Re: Second Submission Review – Green Valley Ranch East Site Plan No. 15 - Site Plan and Plat

Application Number: **DA-1662-26**

Case Number(s): 2022-4014-00; 2022-3019-00

GREEN VALLEY RANCH EAST SITE PLAN #15

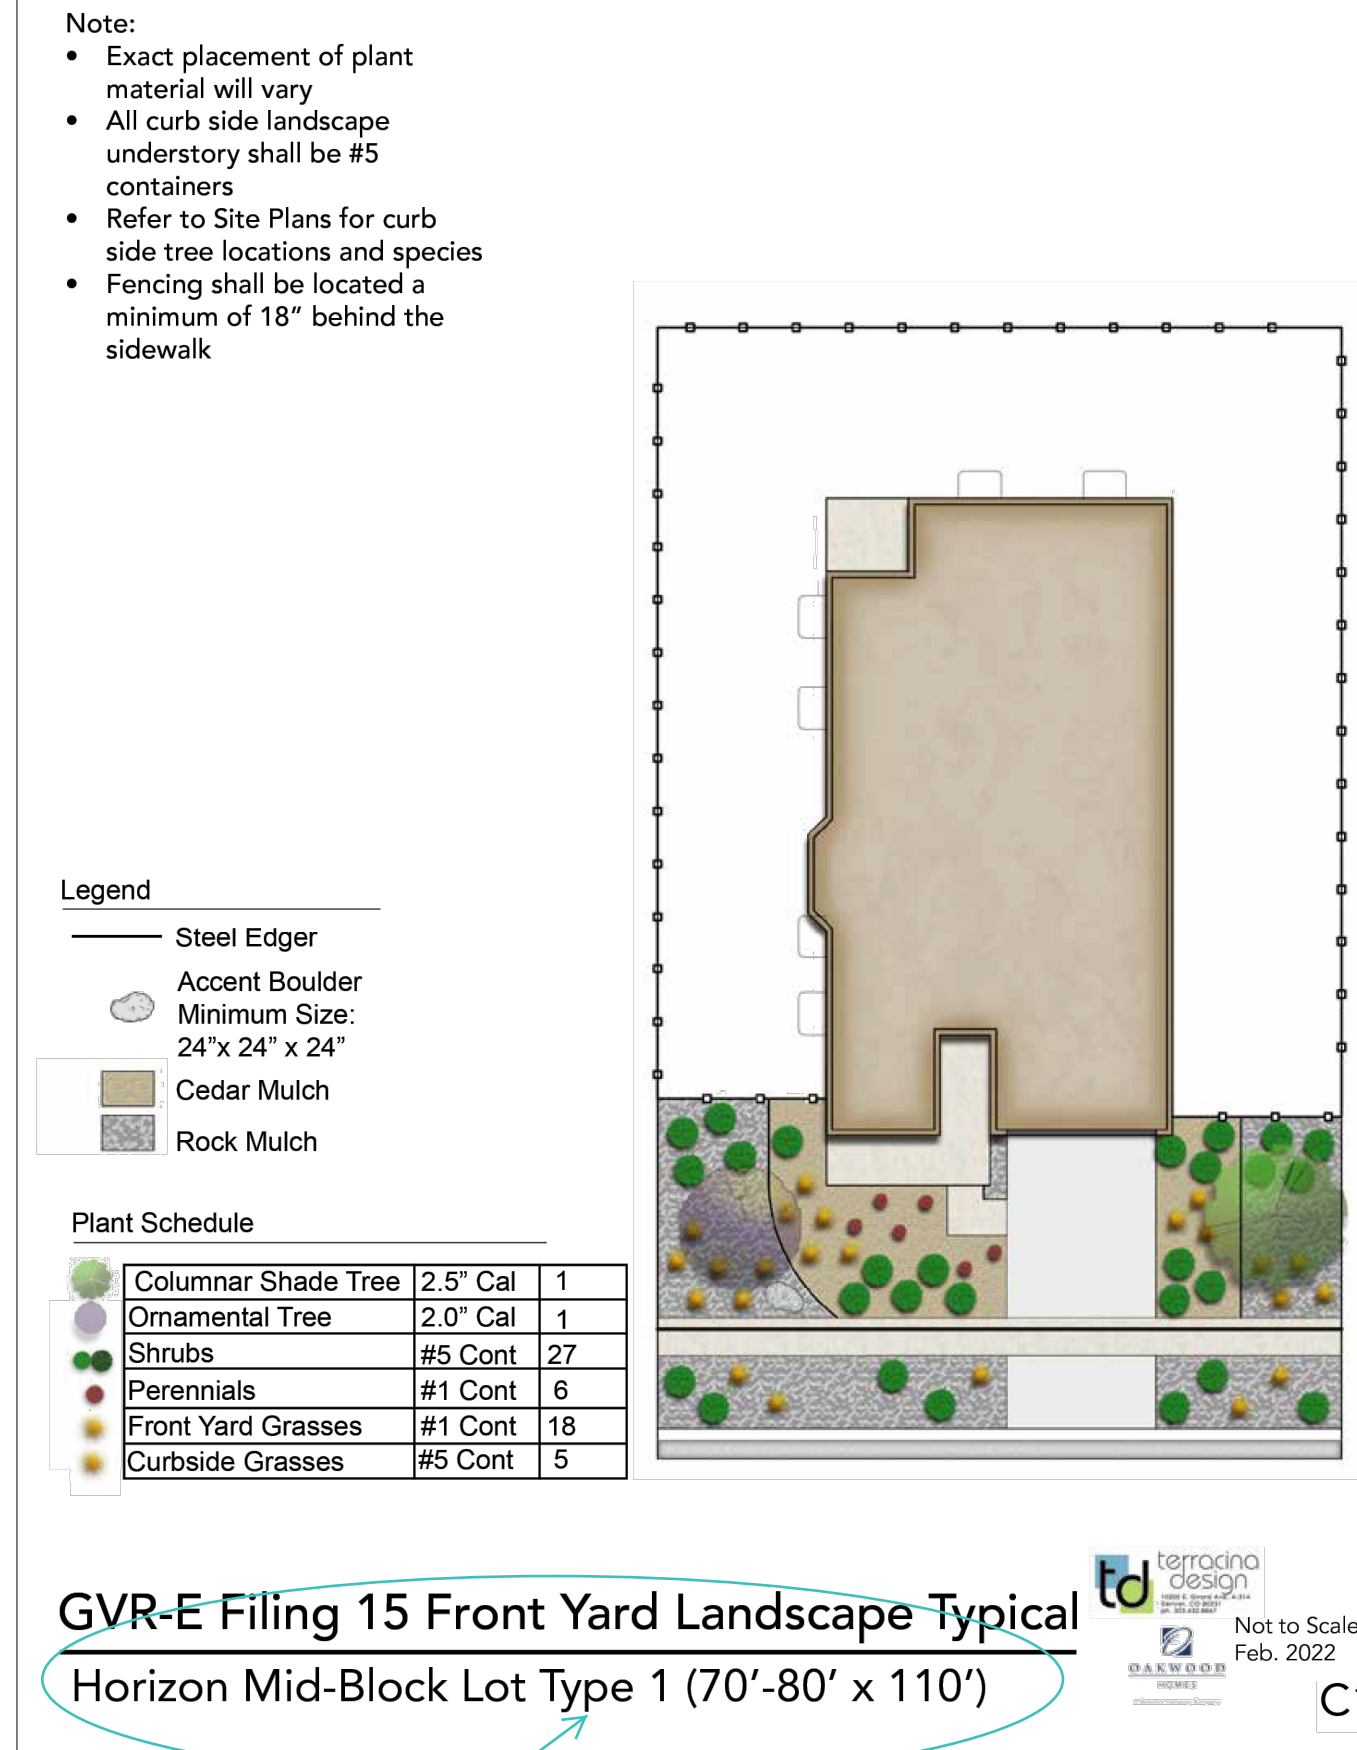
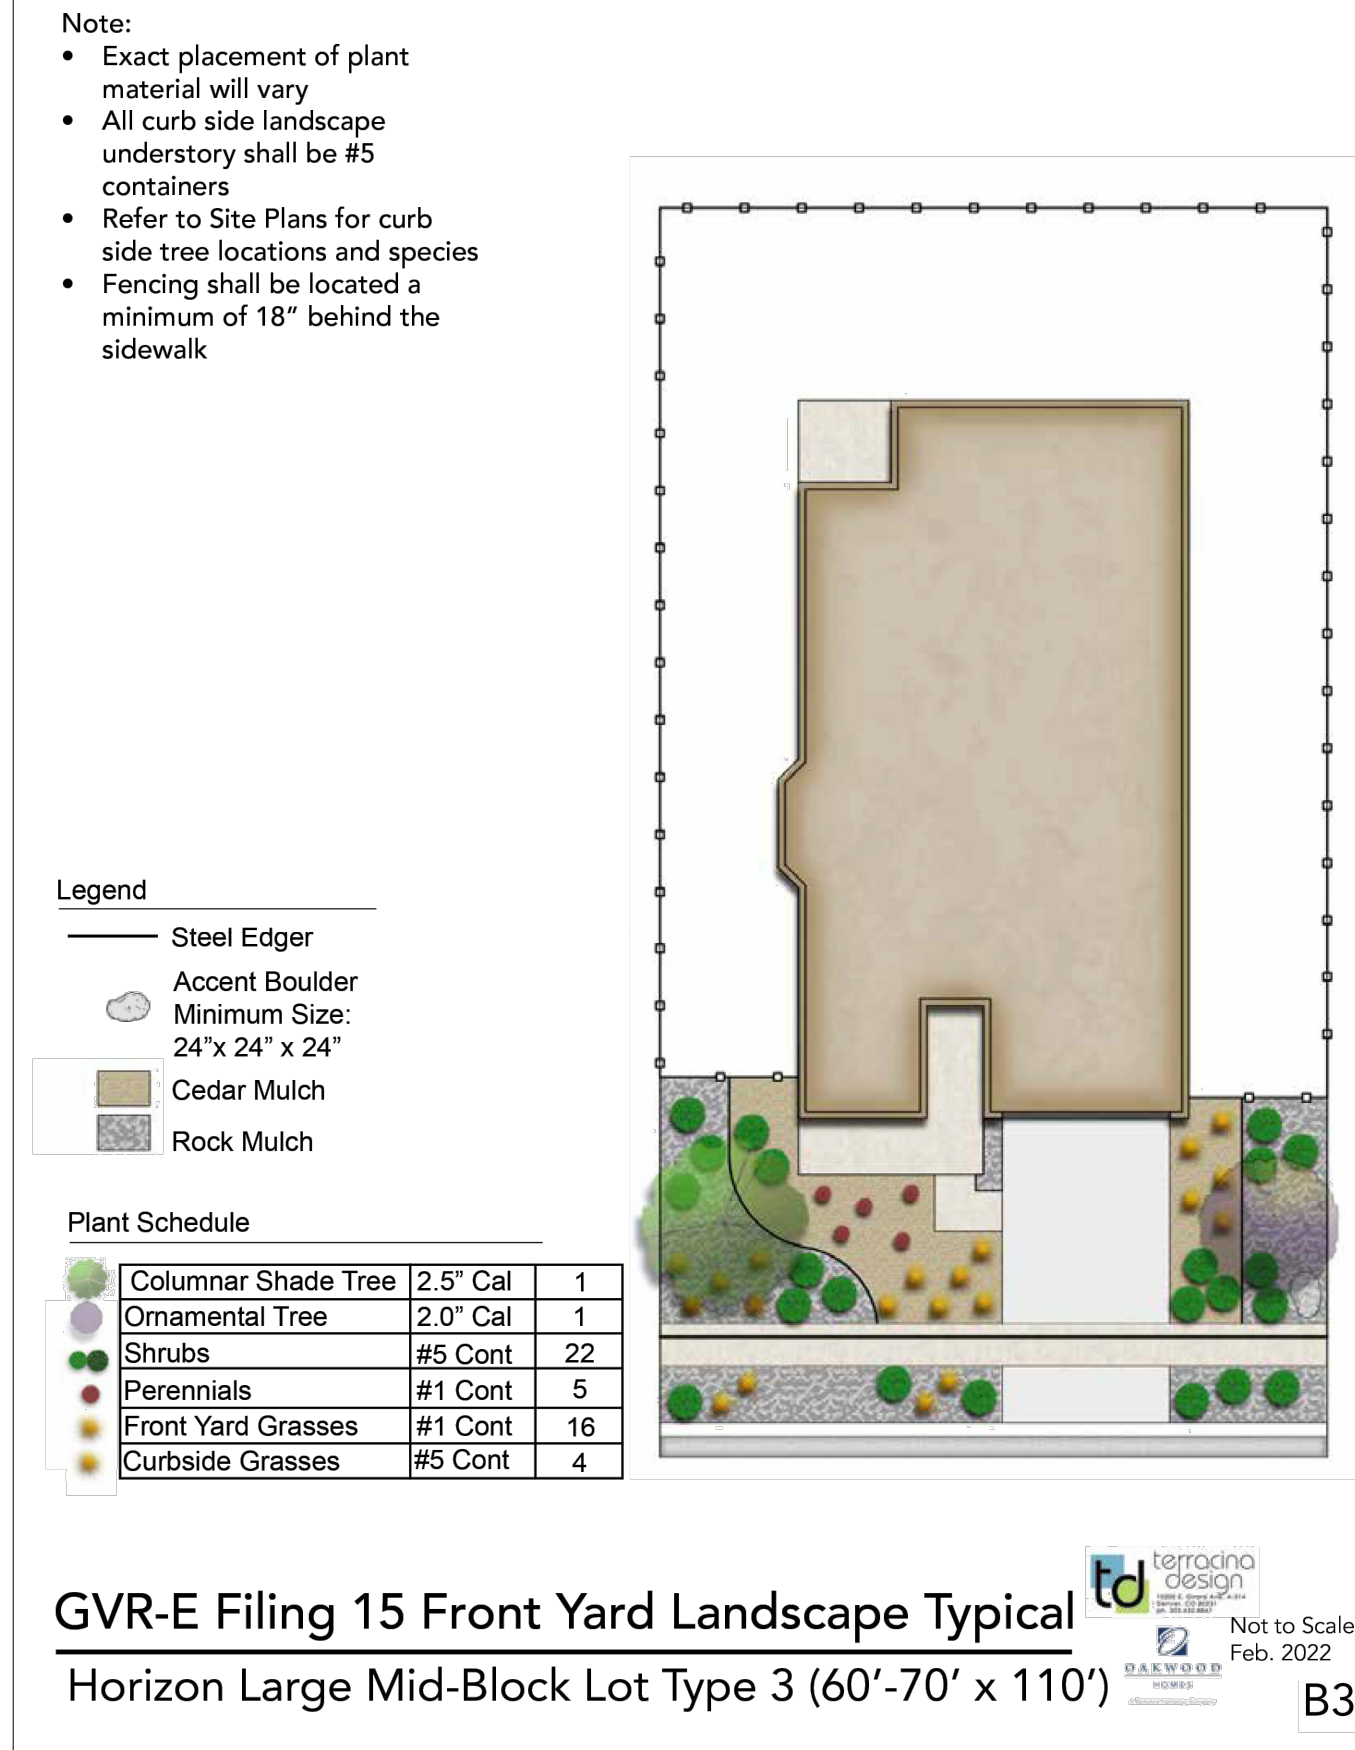
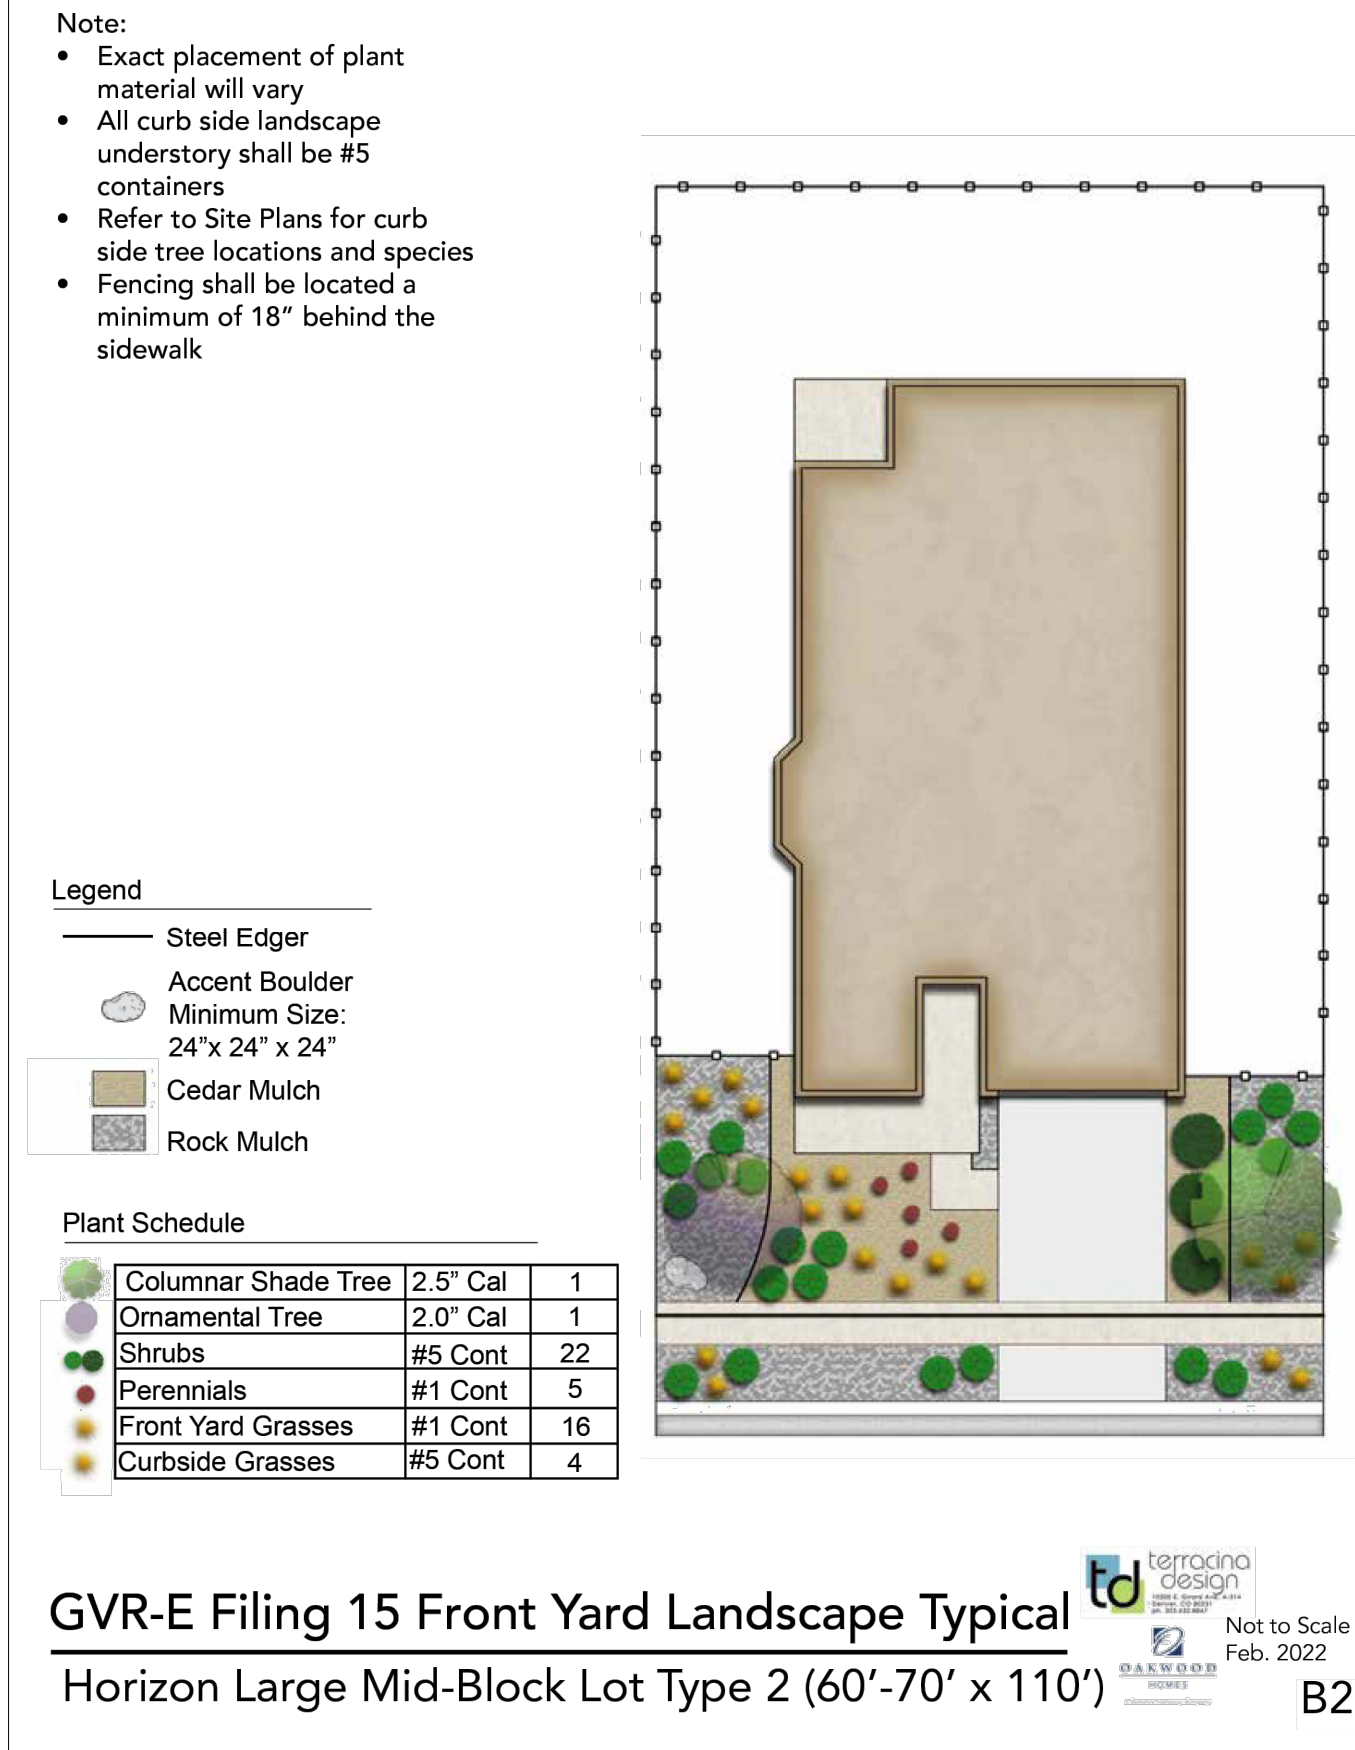
Doesn't match location or size of lots
